AGENDA

PLANNING & ZONING COMMISSION REGULAR MEETING TUESDAY, AUGUST 18, 2026 - 3:30 PM MCALLEN CITY HALL, 1300 HOUSTON AVENUE CITY COMMISSION CHAMBERS, 3RD FLOOR

Subdivision Name	<i>Bravac Park Subdivision</i>
Owner Name	<i>Southmost Solutions, LLC</i>
Engineering Firm	<i>Salinas Engineering and Consultants</i>
Existing Zoning	<i>M-2 (Mix-Use)</i>
Proposed Zoning	<i>M-2 (Mix-Use)</i>
Number of Lots	<i>5</i>

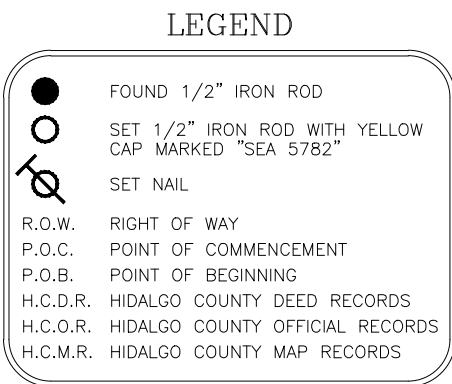
South Ware Road: 60 ft. from centerline for 120 ft. total ROW
 Paving: by the state Curb & gutter: by the state
 - Provide copies of ROW documents referenced on plat for staff review, prior to recording.
 - Label centerline on plat, prior to final.
 **Subdivision Ordinance: Section 134-105
 **Monies must be escrowed if improvements are required prior to final
 **COM Thoroughfare Plan

Erie Avenue: 25 ft. from centerline for 50 ft. total ROW
 Paving: approximately 30 ft. Curb & gutter: both sides
 - Provide document number for existing ROW dedication and provide a copy for staff review, prior to recording.
 **Subdivision Ordinance: Section 134-105
 **Monies must be escrowed if improvements are required prior to final
 **COM Thoroughfare Plan

South 35th Street: Dedication as needed for 30 ft. from centerline for 60 ft. total ROW
 Paving: 40 ft. Curb & gutter: both sides
 - Label centerline and provide a copy of existing ROW dedication for staff review, prior to recording.
 **Subdivision Ordinance: Section 134-105
 **Monies must be escrowed if improvements are required prior to final
 **COM Thoroughfare Plan

- Revisions required
 - Please remove the "Private Drive" "50.00" off the plat. As this is confusing and it is only an access drive.

ALLEYS	
ROW: 20 ft. Paving: 16 ft. - Proposing: A minimum 24 ft. private service drive easement will be established at part of the site plan and will be maintained by the lot owners and not the City of McAllen. - Engineer must get with property to the north to determine service drive location to provide for extension and internal circulation as required by Traffic Department *Alley/service drive easement required for commercial properties **Subdivision Ordinance: Section 134-106	Compliance
SETBACKS

* Front: In accordance with the UDC or greater for easements or approved site plan, whichever is greater applies. - M-2 has a front yard setback of Min of 5ft. and Max of 25 ft. - Revise plat note as shown above, wording to be finalized. **Zoning Ordinance: Section 138-356 * Rear: In accordance with the UDC or greater for easements or approved site plan, whichever is greater applies. **Zoning Ordinance: Section 138-356 * Sides: In accordance with the UDC or greater for easements or approved site plan, whichever is greater applies. **Zoning Ordinance: Section 138-356 * Corner: In accordance with the UDC or greater for easements or approved site plan, whichever is greater applies. - Corner has a min of 15ft corner setback under the new M2 District. **Zoning Ordinance: Section 138-356 * Garage _____ **Zoning Ordinance: Section 138-356 *ALL SETBACKS ARE SUBJECT TO INCREASE FOR EASEMENTS OR APPROVED SITE PLAN	Required

Subdivision Name	<i>Coastal King- Mcallen Subdivision</i>
Owner Name	<i>Ray Smith Family Partnership/ H. Ray Smith</i>
Engineering Firm	<i>Ramior Gutierrez</i>
Existing Zoning	<i>C-3 General Business</i>
Proposed Zoning	<i>C-3 General Business</i>
Number of Lots	<i>3</i>

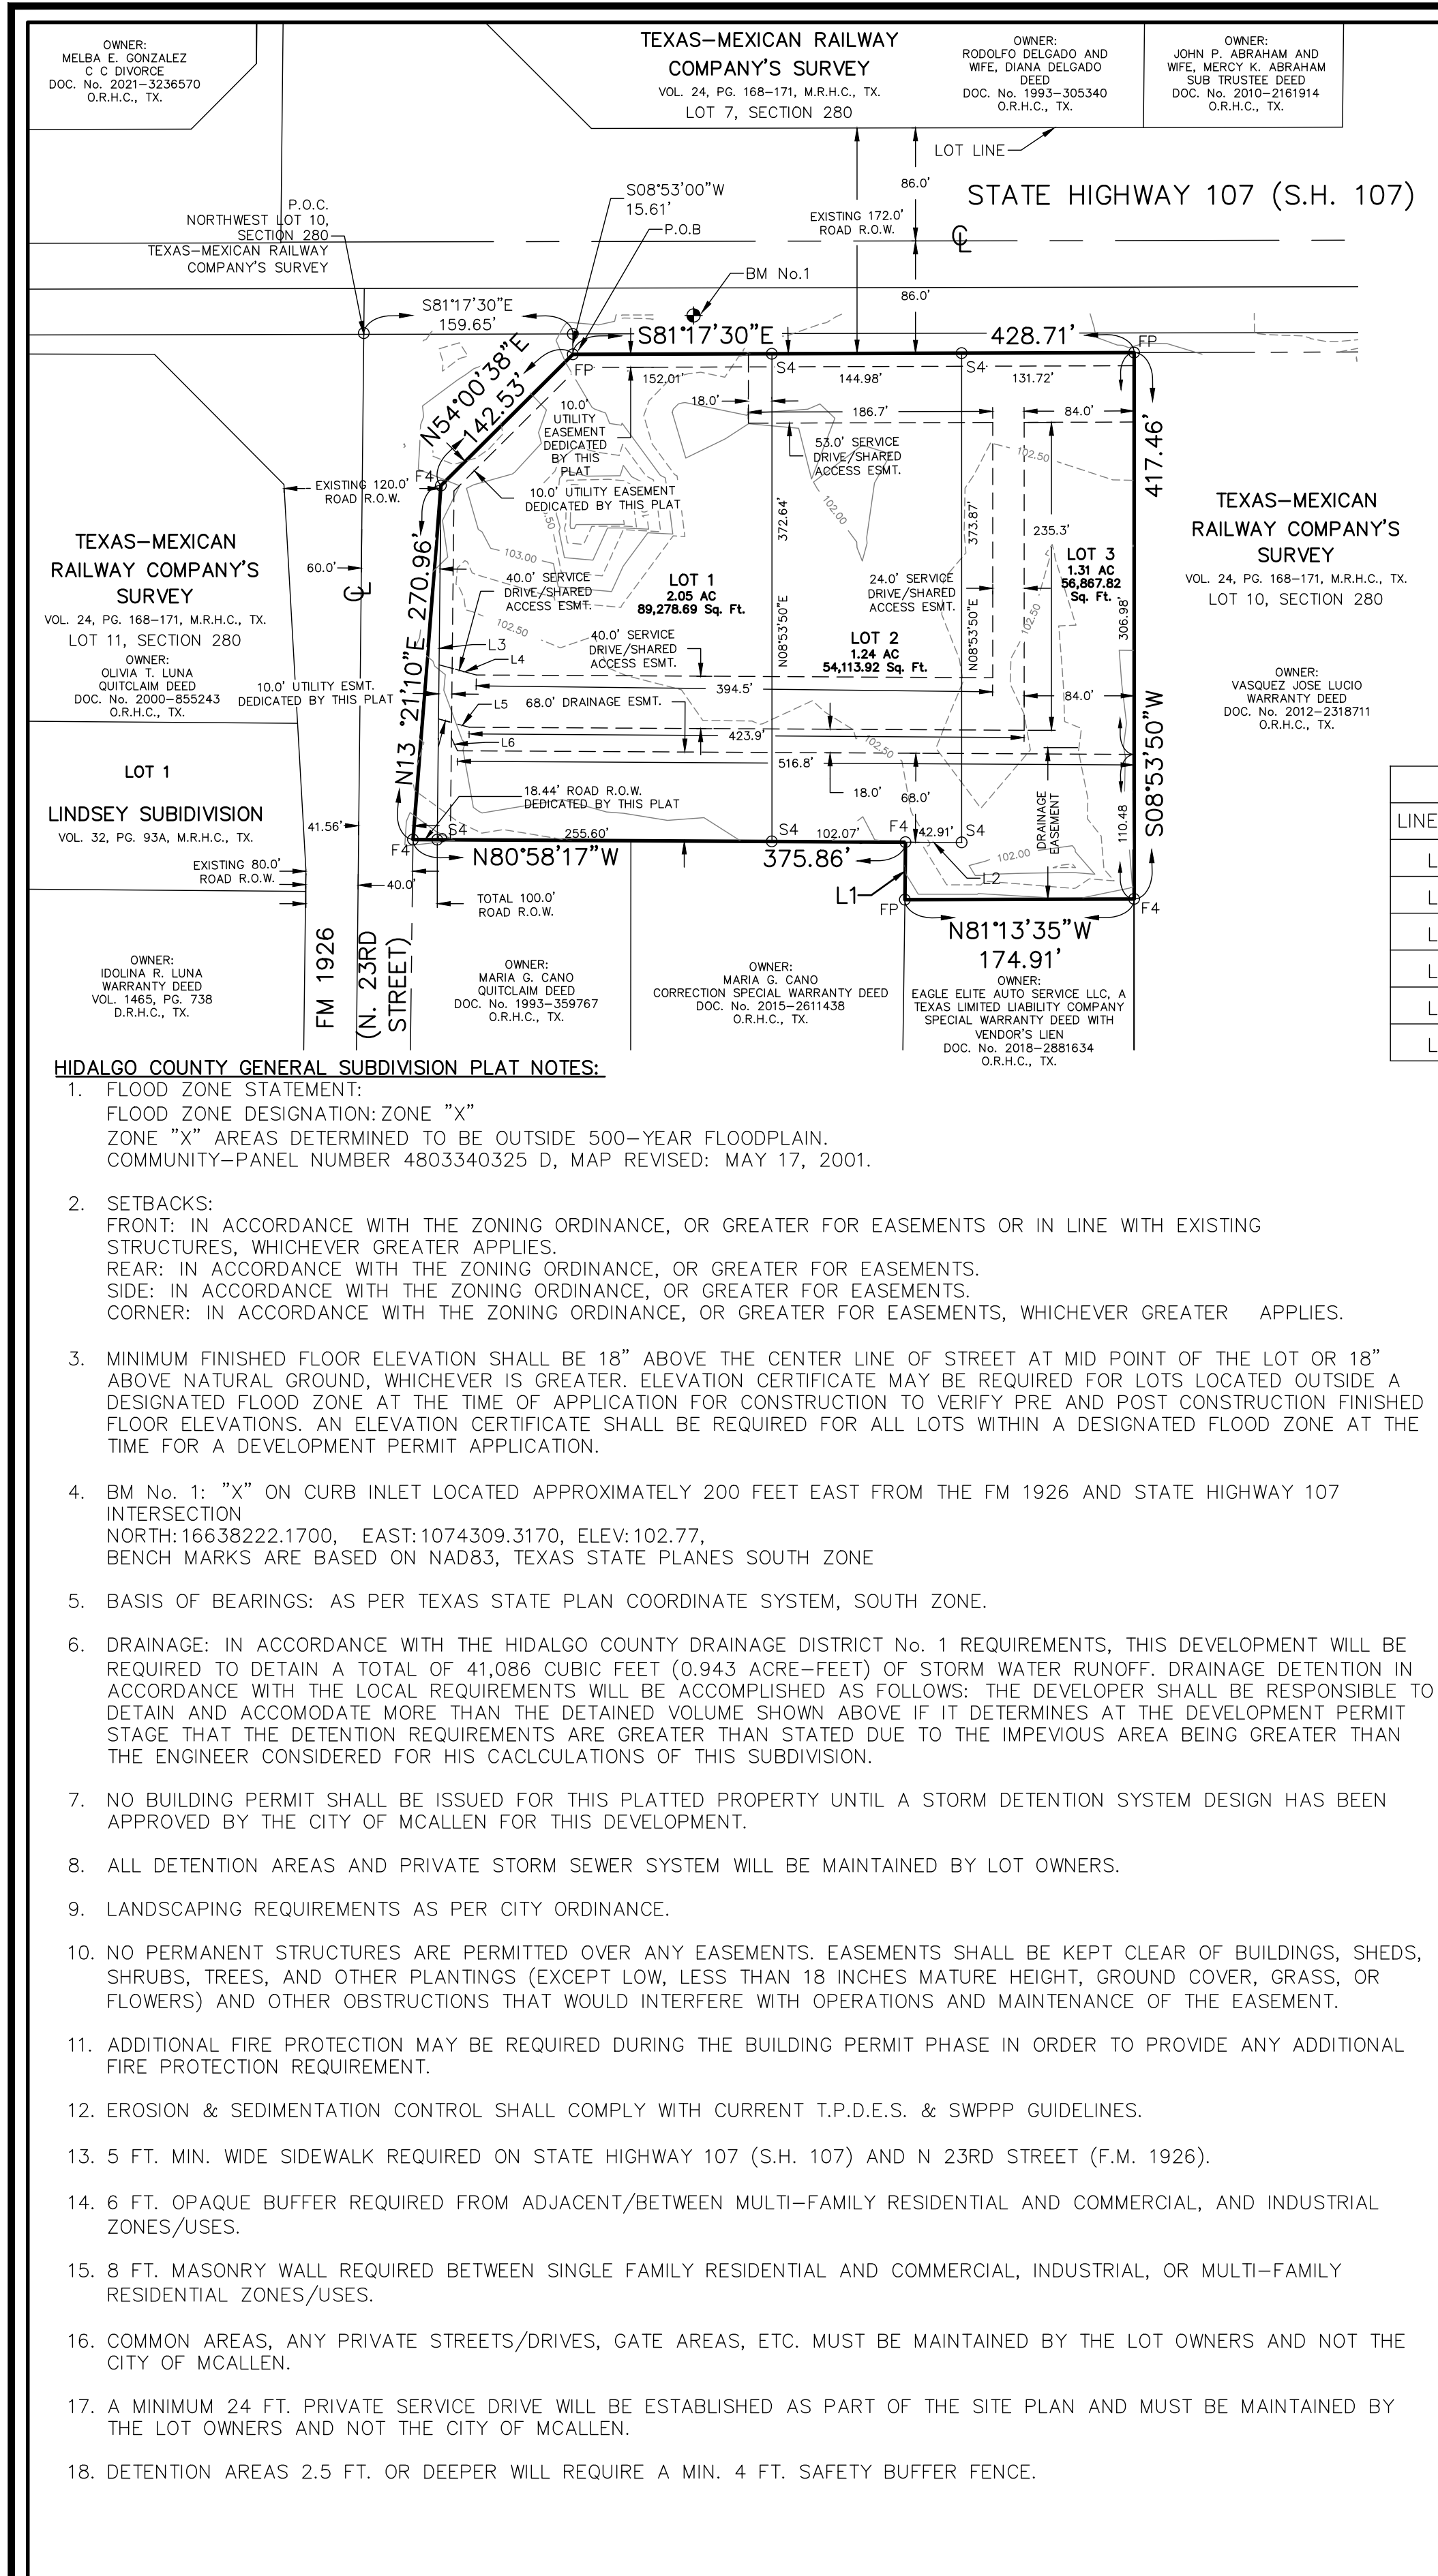
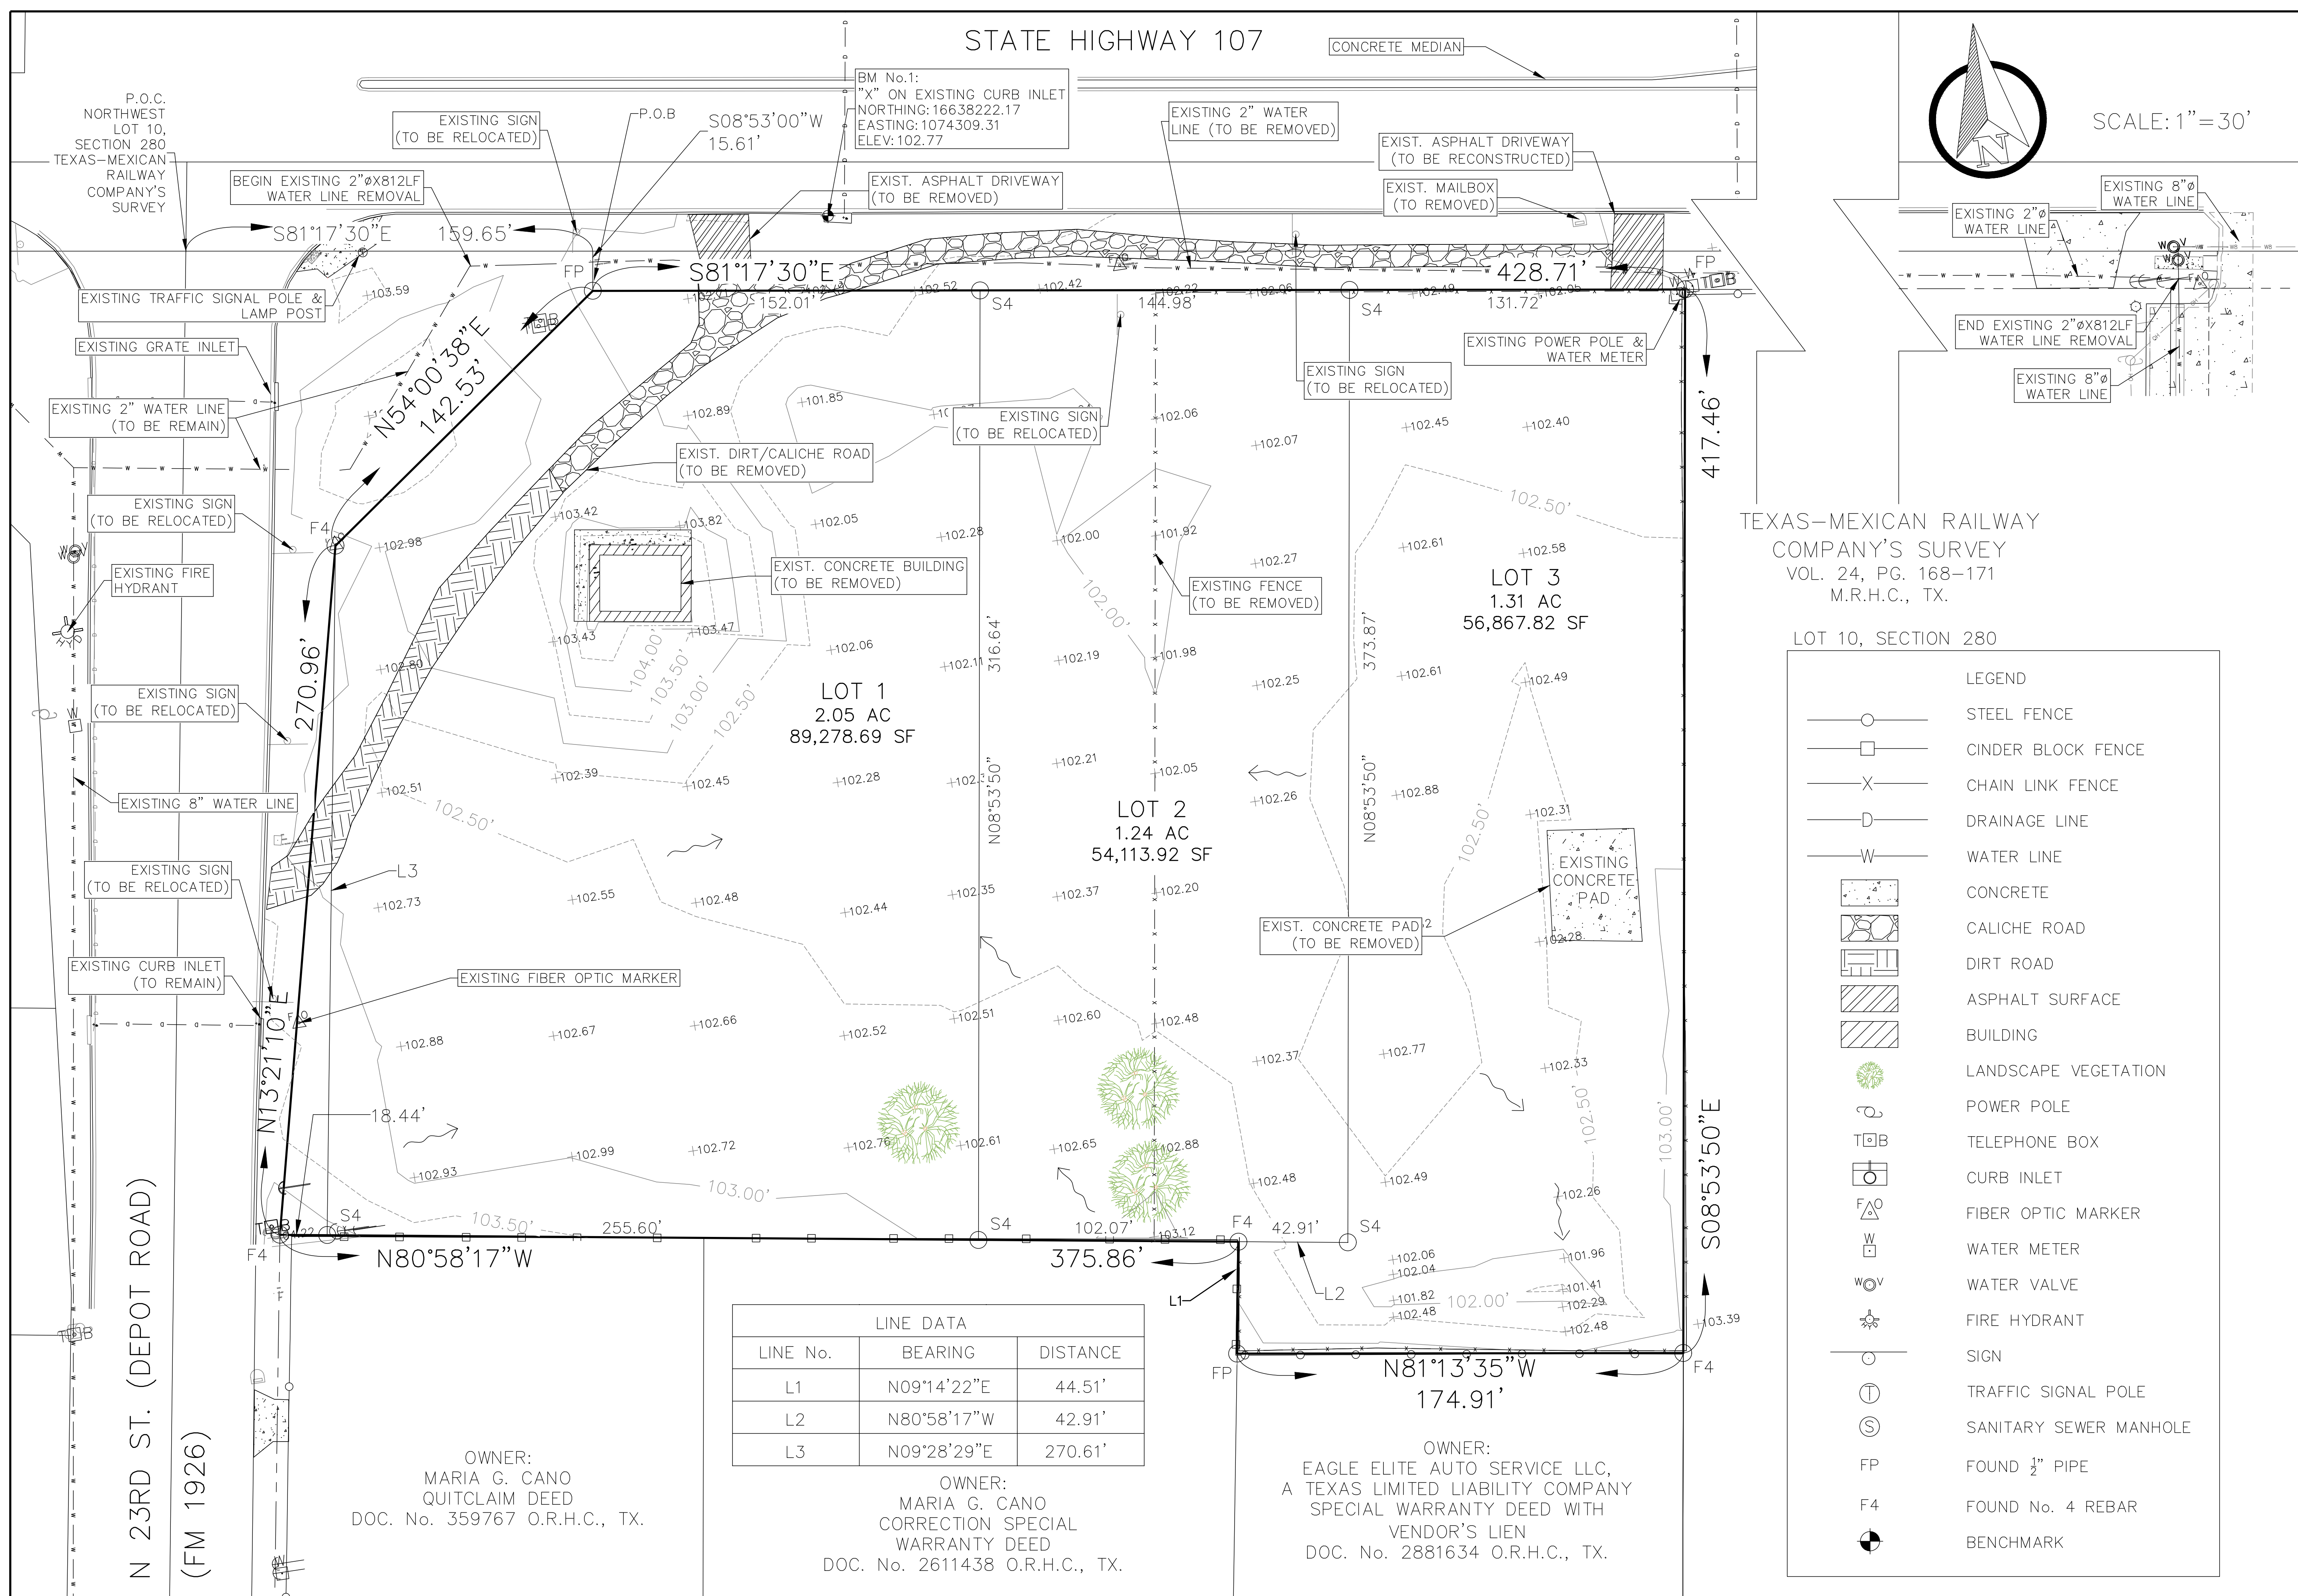
State Highway 107 (S.H. 107): 86 ft. from centerline for 172 ft. total existing R.O.W.
 Paving: by the state Curb & gutter: by the state
 *Disclaimer: Any abandonments must be done by a separate instrument/document, cannot be abandoned by plat.
 **Subdivision Ordinance: Section 134-105
 **Monies must be escrowed if improvements are required prior to final
 **COM Thoroughfare Plan

N. 23rd Street (F.M 1926): Dedicate 60 ft. from centerline for a total of 120 ft. ROW.
 Paving: by state Curb & gutter by state
 Revisions Required:
 - Please label "total, existing, etc" on ROW, prior to final.
 - show
 **Subdivision Ordinance: Section 134-105
 **Monies must be escrowed if improvements are required prior to final
 **COM Thoroughfare Plan

ALLEYS	
ROW 20 ft. Paving 16 ft. *Alley/service drive easement required for commercial properties. -- Engineer must clarify if alley or service drive will be provided, prior to final. Alley or service drive cannot dead-end. - If service drive is proposed a plat note stating "A minimum 24 ft. private service drive will be established as part of the site plan and must be maintained by the lot owners and not the City of McAllen", prior to final. **Subdivision Ordinance: Section 134-106	Compliance
SETBACKS	
Front: In accordance with the zoning ordinance, or greater for easements or in line with existing structures, whichever greater applies. **Zoning Ordinance: Section 138-356 * Rear: In accordance with the zoning ordinance or greater for easements. **Zoning Ordinance: Section 138-356 * Sides In accordance with the zoning ordinance, or greater for easements. **Zoning Ordinance: Section 138-356 * Corner: In accordance with the zoning ordinance, or greater for easements, whichever greater applies. - add plat note as stated above, prior to final. *(Proposing) 15 ft. **Zoning Ordinance: Section 138-356 * Garage - this is a commercial development, **Zoning Ordinance: Section 138-356 *ALL SETBACKS ARE SUBJECT TO INCREASE FOR EASEMENTS OR APPROVED SITE PLAN	Compliance

Compliance
	Compliance
	Compliance
	NA
	Applied
SIDEWALKS	
5 ft. wide minimum sidewalk required on State Highway 107 (S.H.107) and N. 23rd Street (FM 1926) - Add plat note as stated above, prior to final. -May increase to 5 ft. as per Engineering Department and TXDOT Requirements. **Subdivision Ordinance: Section 134-120 * Perimeter sidewalks must be built or money escrowed if not built at this time.	Compliance
	Applied
BUFFERS

* 6 ft. opaque buffer required from adjacent/between multi-family residential and commercial, and industrial zones/uses - Add plat note as stated above, prior to final. **Landscaping Ordinance: Section 110-46 * 8 ft. masonry wall required between single family residential and commercial, industrial, or multi-family residential zones/uses - Add plat note as stated above, prior to final. **Landscaping Ordinance: Section 110-46 *Perimeter buffers must be built at time of Subdivision Improvements.	Compliance
	Compliance
	Applied
